Access Compliance Report

Public Rights-of-Way

(Curb Ramps)

Intersection ID: 10021488	Main Street: BOSTON_AV	Cross Street: N/A	Location: SW
ADA ID: C234B839FC9F	Ramp Type: PerpDiag	Initial Pass/Fail: Fail	Overall Compliance: No
		Severity Score: 60

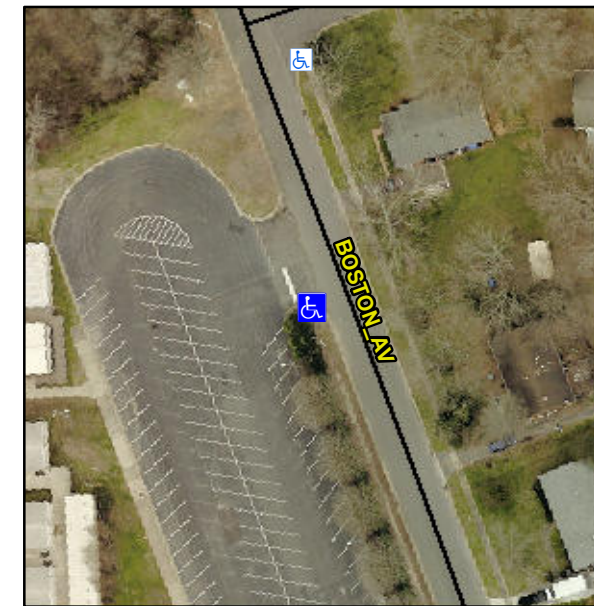
Not Found, R304.5.1, R304.5.3

Compliance	Description	Data	Compliance	Description	Data
N/A	Ramp Length (in)	90.0	Yes	Ramp Slope (%)	6.4
No	Ramp Width (in)	25.0	No	Ramp XSlope (%)	7.8
N/A	Flare Type LT	N/A	N/A	Flare Type RT	N/A
N/A	Flare Slope LT (%)	N/A	N/A	Flare Slope RT (%)	N/A
N/A	Flare Traversable LT?	N/A	N/A	Flare Traversable RT?	N/A
N/A	Landing Length (in)	N/A	N/A	DWS Provided?	N/A
N/A	Landing Width (in)	N/A	N/A	DWS Contrast?	N/A
N/A	Landing Slope (%)	N/A	N/A	DWS Length (in)	N/A
N/A	Landing X Slope (%)	N/A	N/A	DWS Full Width?	N/A
N/A	Landing Curb? (Y/N)	N/A	N/A	DWS Offset (in)	N/A
N/A	Shared Landing?	N/A			
N/A	Gutter Ponding?	N/A	N/A	Gutter Slope (%)	N/A
N/A	Gutter Lip Ht (in)	N/A	N/A	Gutter X Slope (%)	N/A
N/A	Painted X Walk1?	No	N/A	Painted X Walk2?	No
	X Walk 1 Direction	To E		X Walk 2 Direction	To N
N/A	X Walk 1 Width (in)	N/A	N/A	X Walk 2 Width (in)	N/A
	X Walk 1 Slope (%)	1.4		X Walk 2 Slope (%)	2.6
	X Walk 1 X Slope (%)	1.6		X Walk 2 X Slope (%)	14.2

Remove & Replace Curb Ramp With Two New Directional Ramps or Equivalent.
